A Review of the Calculation of the Concentration of Dioxin Sorbed to Bed Sediment: Gunns' Draft Integrated Impact Statement

Dr Andrew W. Wadsley
Australian Risk Audit
consult@ariska.com
May 2007

A review was undertaken of the calculation of dioxin sorbed to bed sediment in Gunns' draft Integrated Impact Statement. This review found that calculation errors, failure to include background dioxin concentrations, and failure to use the permitted maximum limit of dioxin in the pulp mill effluent, results in an underestimation of dioxin concentrations by a factor of 1,390 in the *Human Health Risk Assessment* and by a factor of 90 in the *Marine Impact Assessment*.

Figure 3.1: Summary of Toxicos Equations

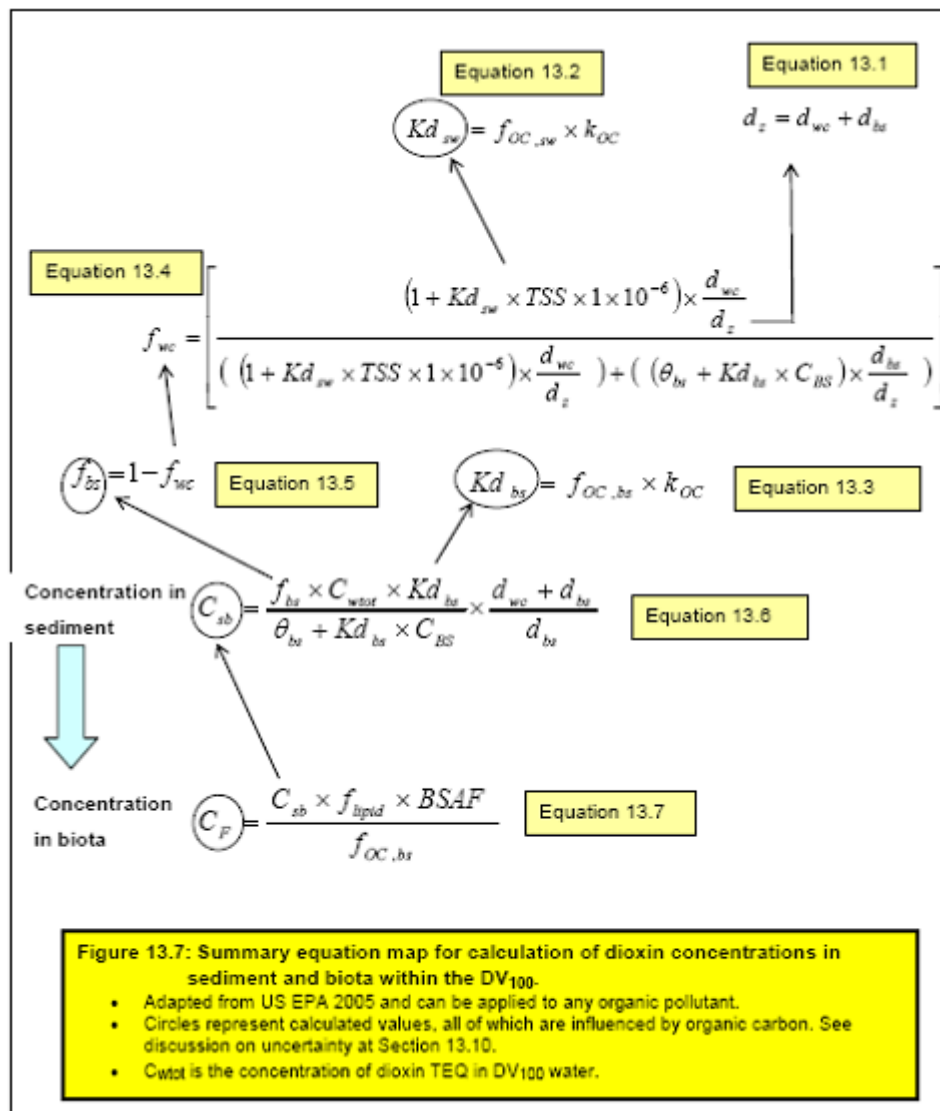
Toxicos summarise the equations used to calculate the concentration of dioxin in the sediment within this DV₁₀₀ in their Figure 13.7 ([6] p.159), presented here in **Figure 3.1**.

Their Equation 13.6 is the same as Equation 5-47 cited in the US EPA protocol given here in **Figure 3.2**. COPC is an acronym for *Compound of Particular Concern*, in this case *dioxin*.

In US EPA Equation 5-47 Toxics incorrectly set the parameter C_{wtot} equal to the dioxin concentration in the water: C_{wtot} is actually the concentration of dioxin in the water column and sediment. The definitions of the variables they use are given in their Table 13.9 ([6] p.160), an extract of which is shown here in **Figure 3.3**. Toxics define the variable C_{wtot} (as used in their equation 13.6) as the “total dioxin concentration in DV₁₀₀ water”.
